World Forum for Harmonization of Vehicle Regulations

Progress on the development of new global technical regulations (gtrs) and of amendments to established global technical regulations (gtrs) – Gtr No. 2 (motorcycles emissions)

Authorization to develop amendments to gtr No. 2 (motorcycles emissions)

Submitted by the representative of Japan*

Figure A13-1: Example of a gearshift sketch

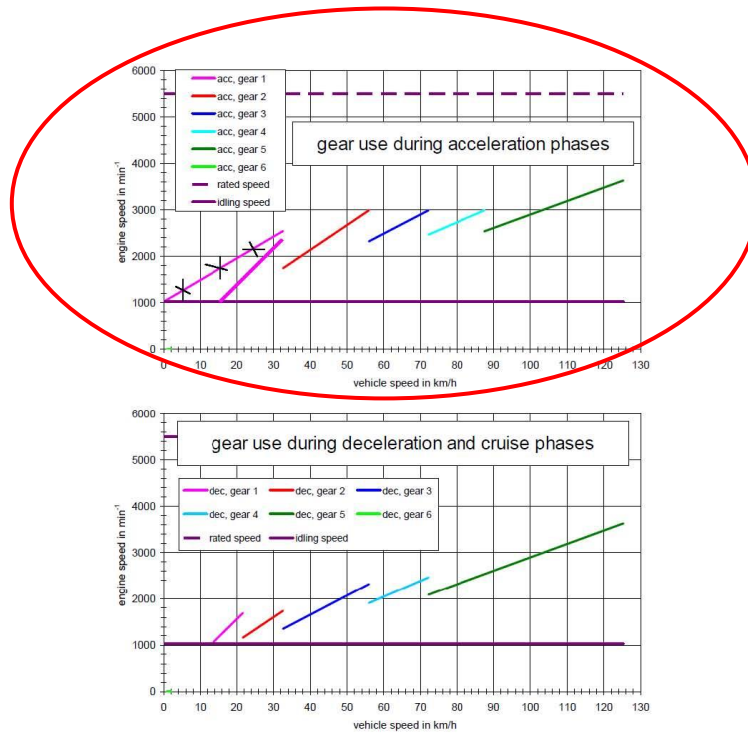
Annex 13, paragraph 1. Figure A13-1, correct the line for "acc.gear 1" in the upper figure for "gear use during acceleration phases" as reproduced below.
